Staff Report

Fairborne Homes Ltd., has applied to the City of Richmond for permission to construct a mixed-use commercial and residential development on a combined site area of 10,106 m² (108,780 ft²) with a proposed 2.99 FAR including a net floor area of 30,208 m² (325,156 ft²). The net floor area breakdown of the proposed development includes 2,178 m² (23,444 ft²) of commercial floor space (new banking hall for Scotiabank) and 28,030 m² (301,712 ft²) of residential floor space consisting of approximately 347 residential units. The development site consists of 6180, 6280 and 6300 No. 3 Road and all lots are zoned Downtown Commercial (CDT1). The site is not being rezoned. The proposed development site currently accommodates the existing Canada Line, Richmond-Brighouse Station (straddling 6180 and 6280 No. 3 Road) and the Scotiabank (BNS) on 6300 No. 3 Road.

No. DP 11-584010

BRIGHOUSE STATION, RICHMOND
DEVELOPMENT PERMIT SUBMISSION
NOV 19 2011 DP 11-004010

LEVEL 1

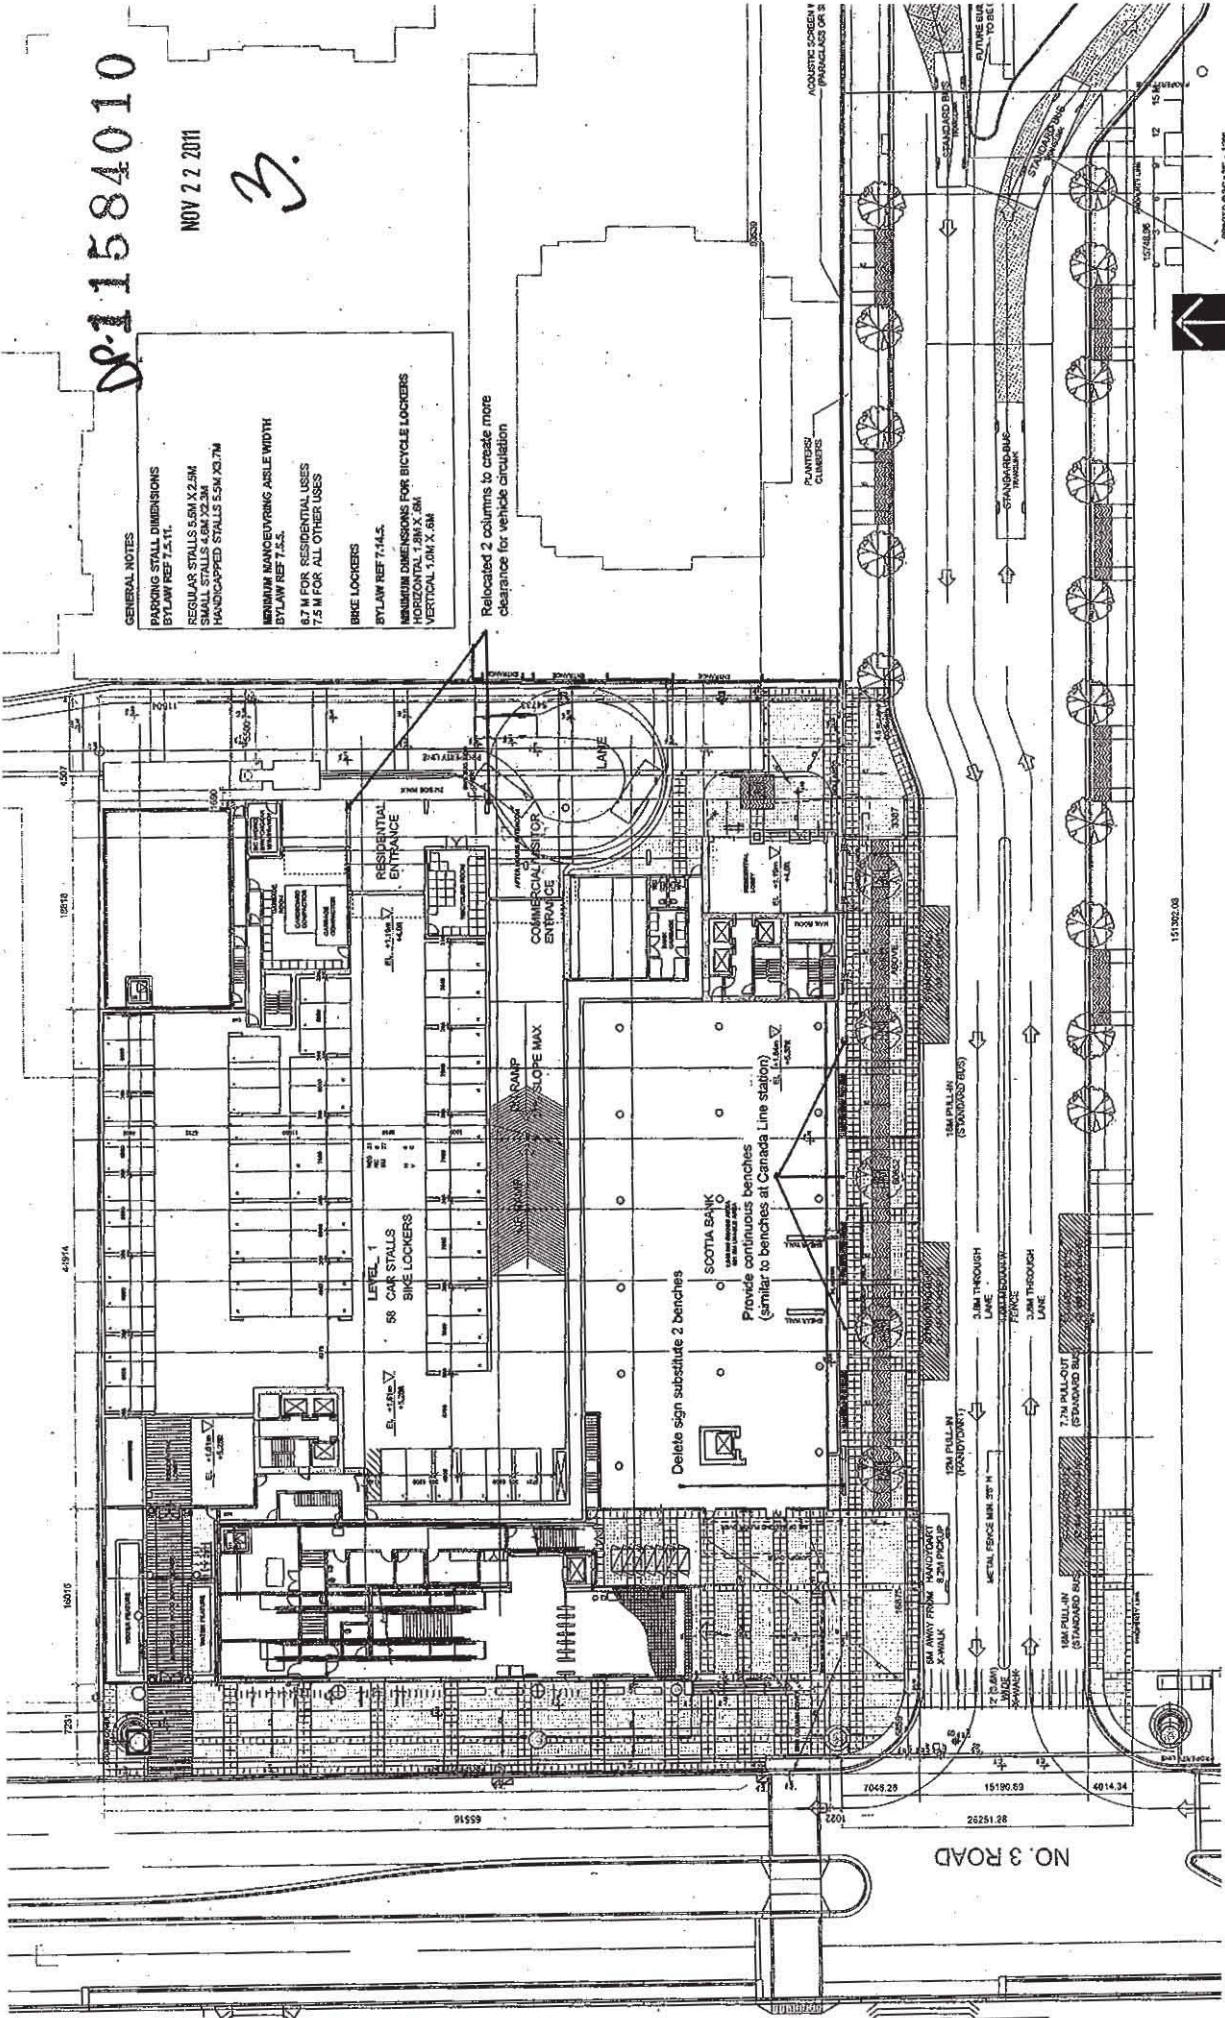
Relocated 2 columns to create more
clearance for vehicle circulation

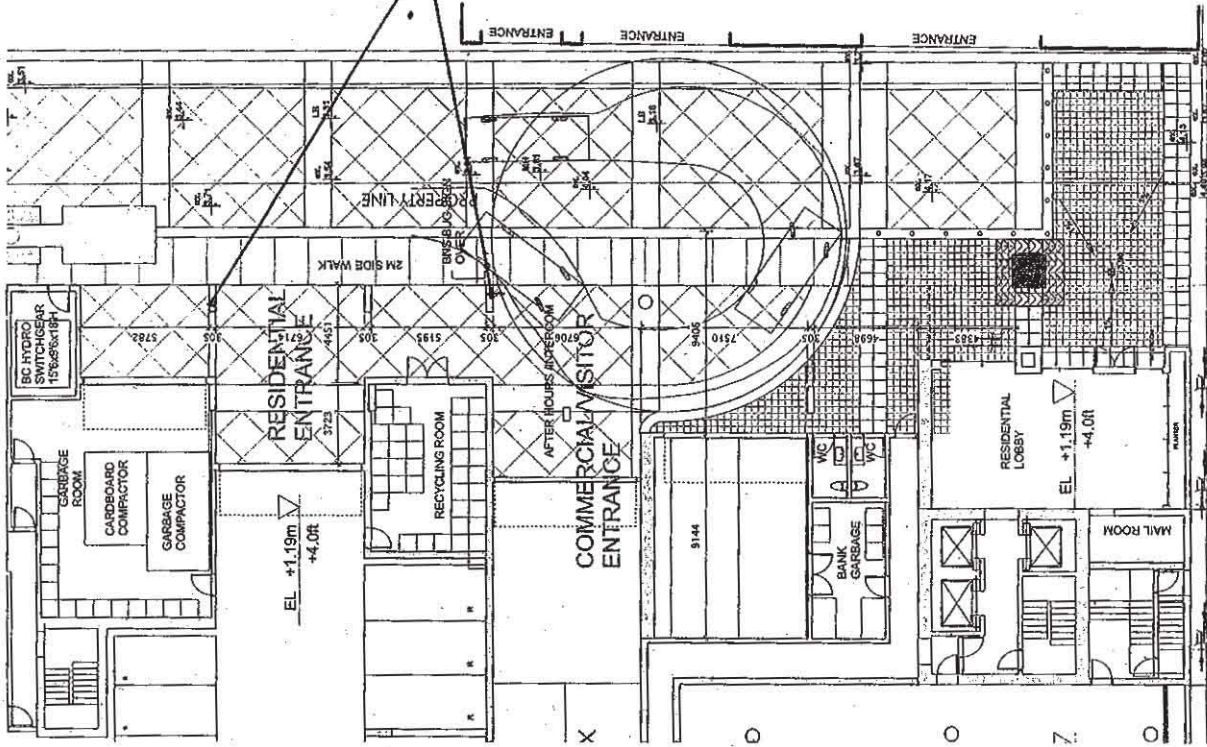
Relocate columns to create more clearance for vehicle circulation
